ECE/TRANS/WP.29/2010/42  
18 December 2009

Proposal for Supplement 1 the original version of Regulation No. 118  
(Burning behaviour of materials)

Submitted by the Working Party on General Safety Provisions \*/

Example 2

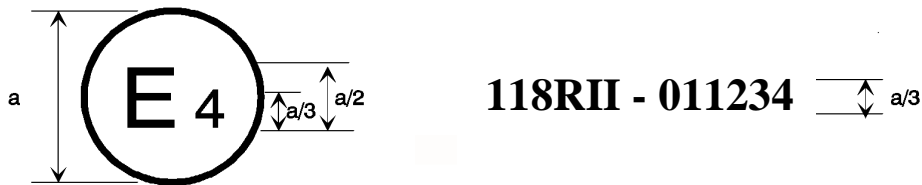
Annex 5, amend to read:

The above approval mark affixed to a component shows that the type concerned was approved in the Netherlands (E4) pursuant to Part II of Regulation No. 118 under approval number 011234. The first two digits (01) of the approval number indicate that the approval was granted in accordance with the requirements of the 01 series of amendments to Regulation No. 118.

Figure 4a  
 Apparatus for testing the capability to repel fuel or lubricant  
 (Dimensions in millimeters)"

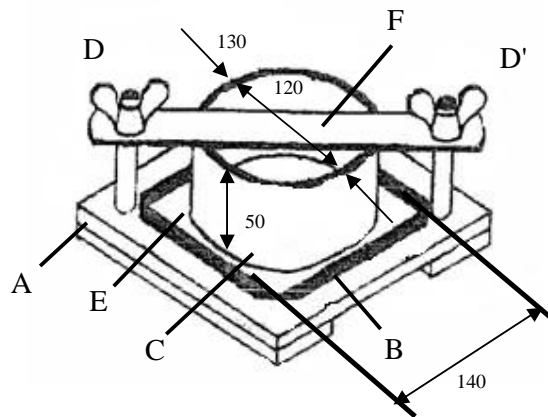
Insert a new Annex 9, to read:

TEST TO DETERMINE THE CAPABILITY OF MATERIALS TO REPEL  
FUEL OR LUBRICANT

3. Apparatus (see figures 4a and 4b)

The apparatus shall consist of:

A a base plate, with a hardness of at least 70 Shore D.

B an absorbant surface on the baseplate (e.g. paper);

C a metal cylinder (inner diameter of 120 mm, outer diameter of 130 mm, height of 50 mm), filled with the test liquid;

D-D' two screws with wing nuts;

E the test sample;

F top plate
